City of Bellevue, Washington

Walk & Roll: 2007 Pedestrian and Bicycle Transportation Plan Public Involvement Report—Part 2

Community Outreach Executive Summary

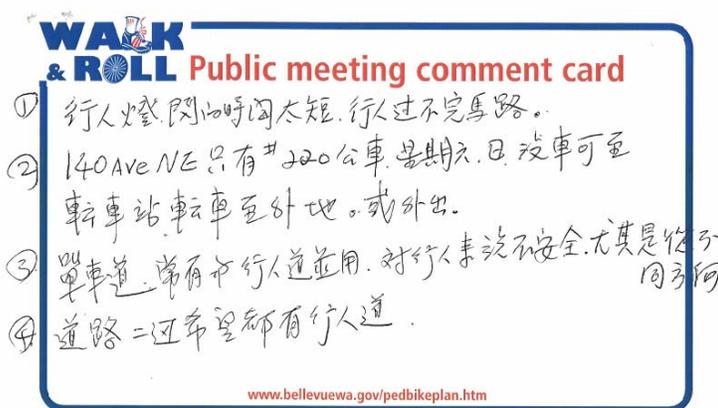
One example (and there are many others) of the way this type of comment has been responded to is the area of Main Street and 107th SE, (see photo-visualization at right), HDR employees indicated: “The narrow sidewalk also contains a fire hydrant, utility grate, and a sandwich board sign, impeding access and forcing pedestrians into the road.”

In response to this input, the City is proposing a new pedestrian project to improve the substandard sidewalk at this location. This new project is identified on the updated project list (also part of the Commission’s packet) as project S07-015: Add an 8 foot wide sidewalk and a 4 foot wide planter strip on the north side of Main Street from Bellevue Way to 116th Ave NE

IMAGE 6

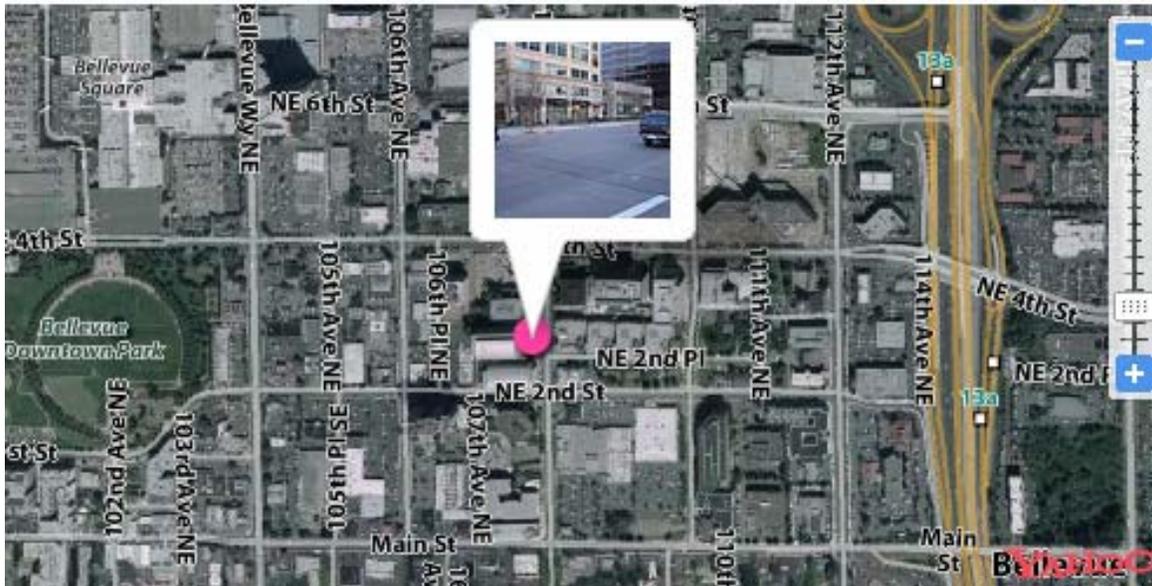
Many pedestrians cross at this location. A designated crosswalk would be helpful. [Concerned Bellevue Pedestrian]

IMAGE 10

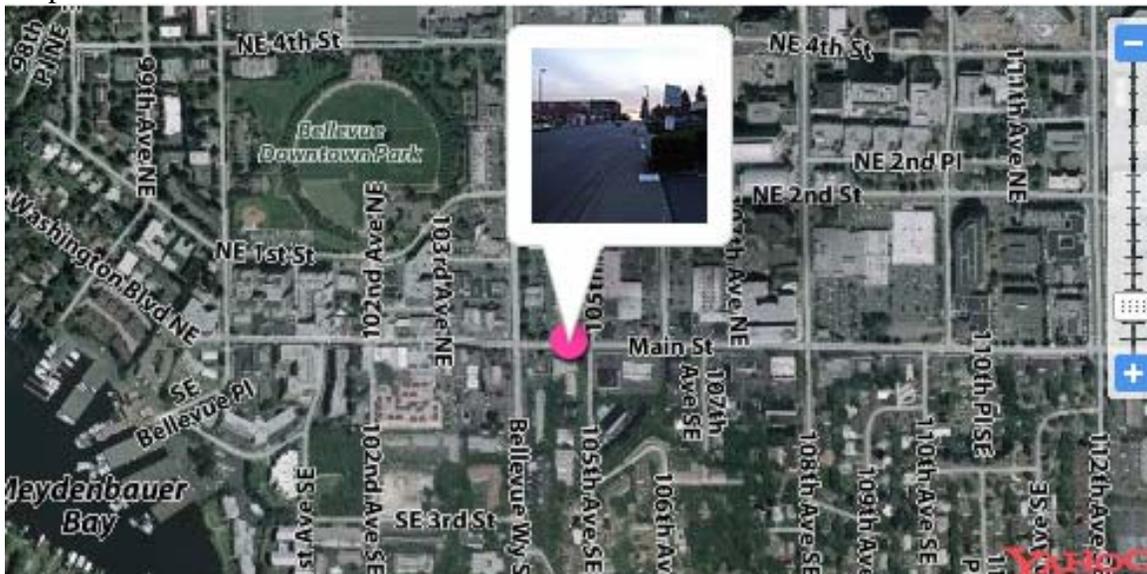
Hedge on the SE corner of 105th NE and Main inhibits driver sight distance into the crosswalk, endangering pedestrians. High speed drivers accessing high school also endanger pedestrians [Concerned Bellevue Pedestrian]

IMAGE 14

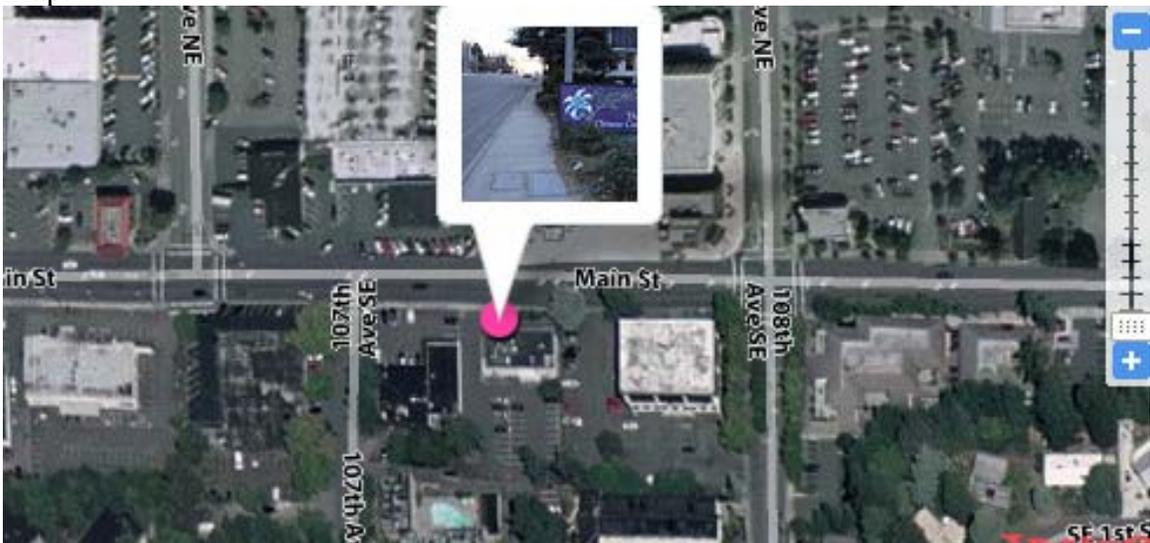
The planter strip vegetation extends out into the sidewalk [Concerned Bellevue Pedestrian]

I-90 – Mountains to Sound Greenway Regional Trail System | **Bellevue to Issaquah Segments**

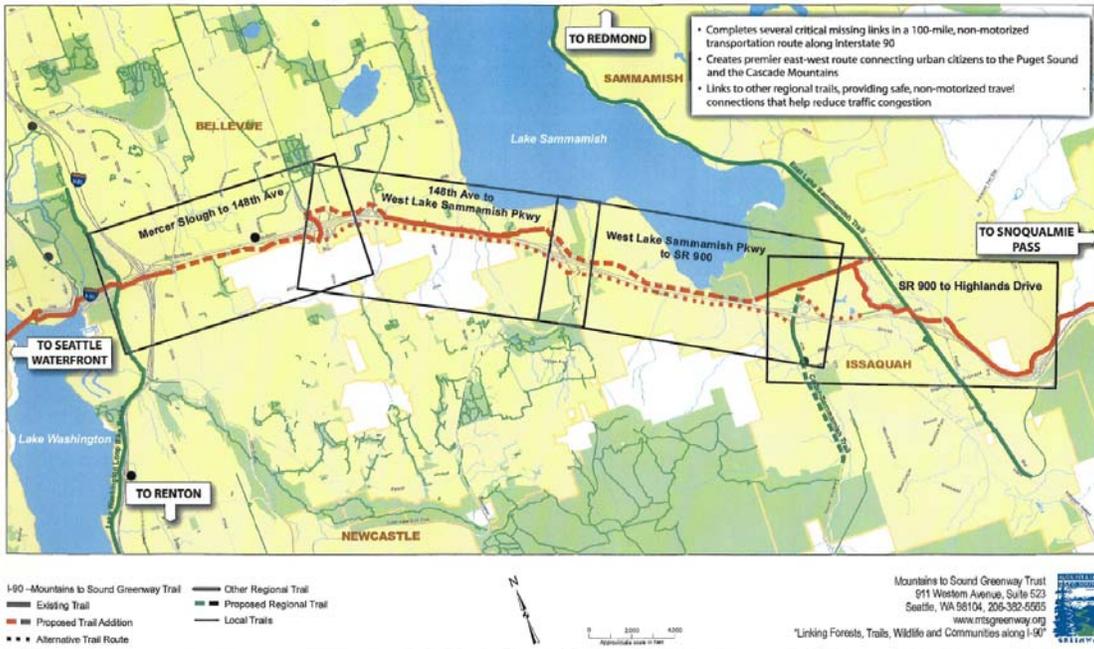
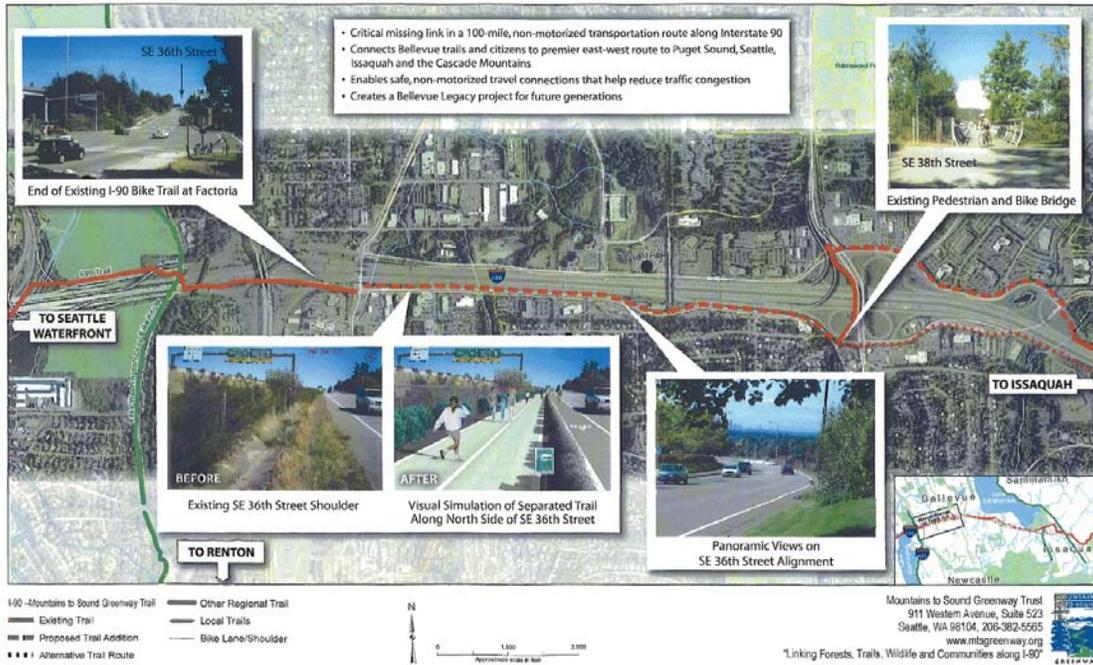
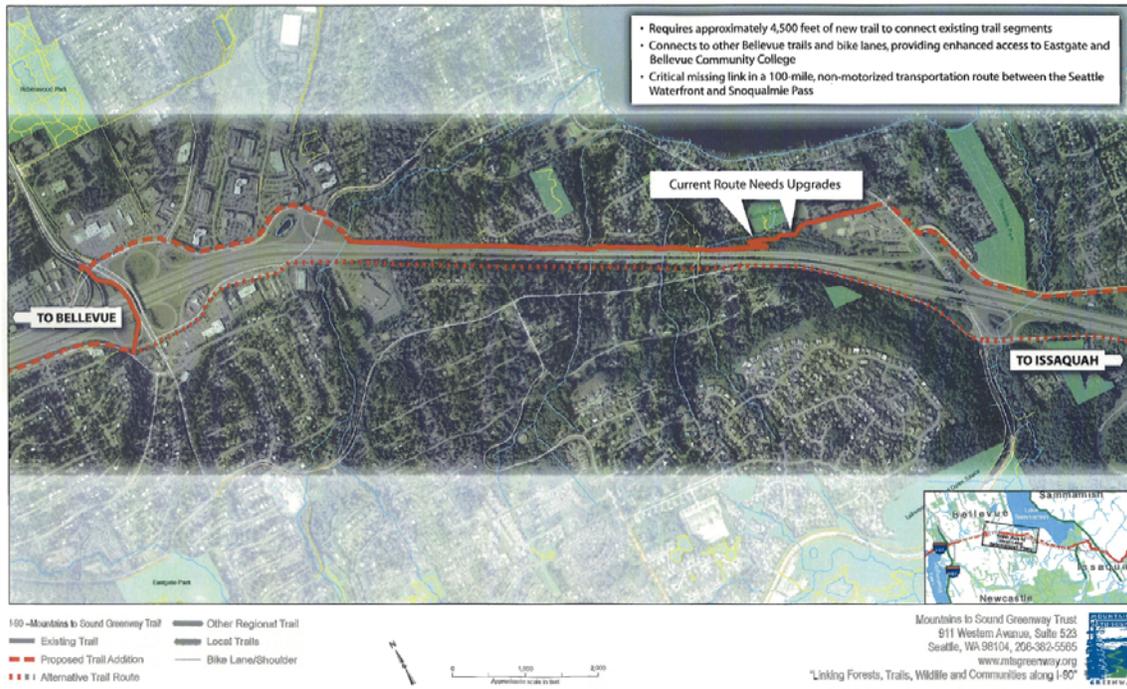
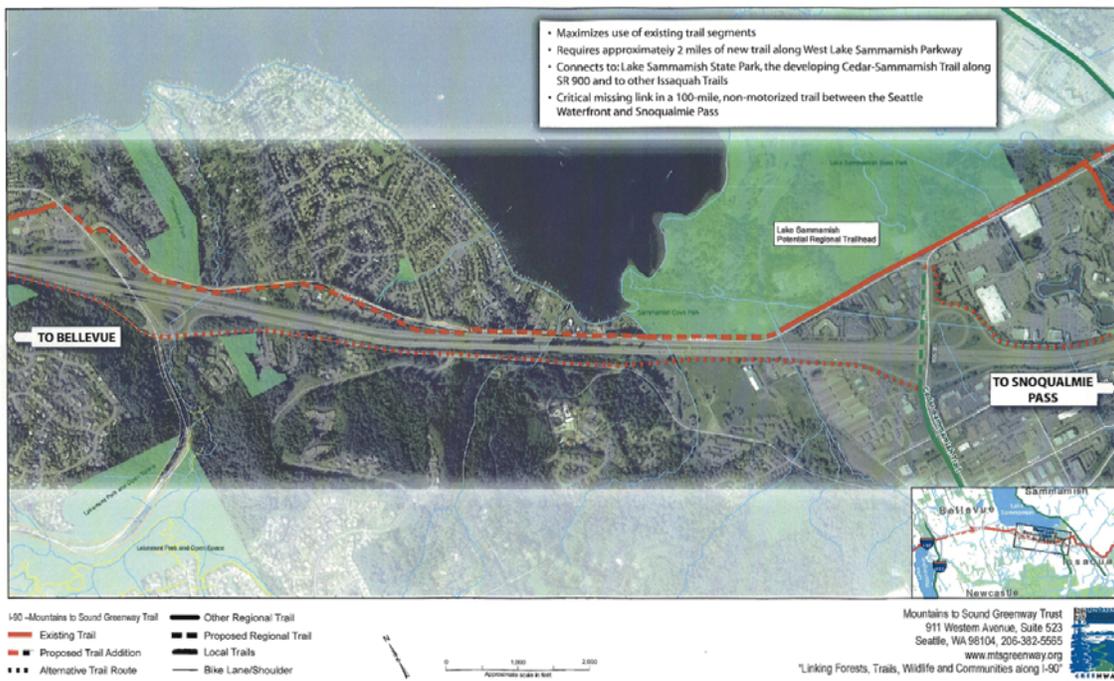
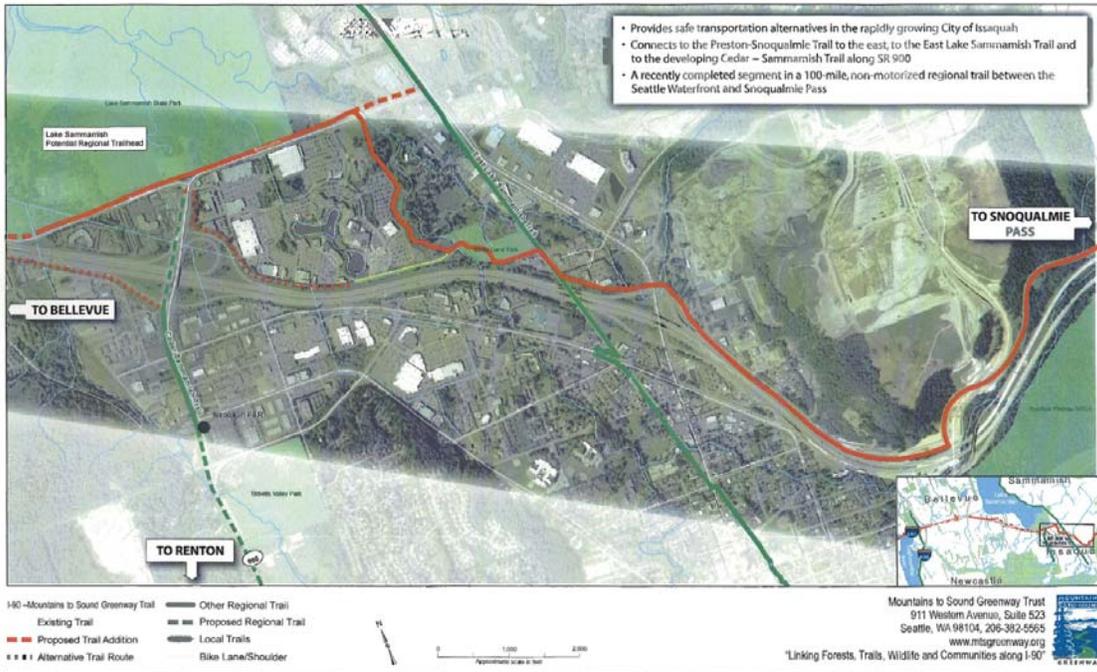
- “The development of Bellevue’s new Pedestrian and Bicycle Transportation Plan presents a unique and important opportunity to fill a missing link in a regional Class I Type A Path that will link Bellevue citizens and people throughout the region to major population centers and 100 miles of recreational opportunities. The Mountains to Sound Greenway I-90 trail system currently begins on north Beacon Hill in Seattle and, with a few gaps, can take walkers, bicyclists and all non-motorized users through the Cascade Mountains to the Columbia River. Soon this trail will connect to Safeco Field and the Seattle waterfront and, under State Parks management, will go all the way to the Idaho border. The Bellevue gap is one of only five short missing links in this system and is approximately 1.9 miles long, from Factoria Boulevard to the existing Sunset Trail at 161st Avenue S.E.” (Letter from Mountains to Sound Greenway Trust, 10/23/07)

In response to this feedback, Staff are recommending that an existing project in the draft network plan be modified to include the entire Mountains to Sound Greenway Corridor, this project (B-256) is identified in more detail in the project list that is part of the packet.
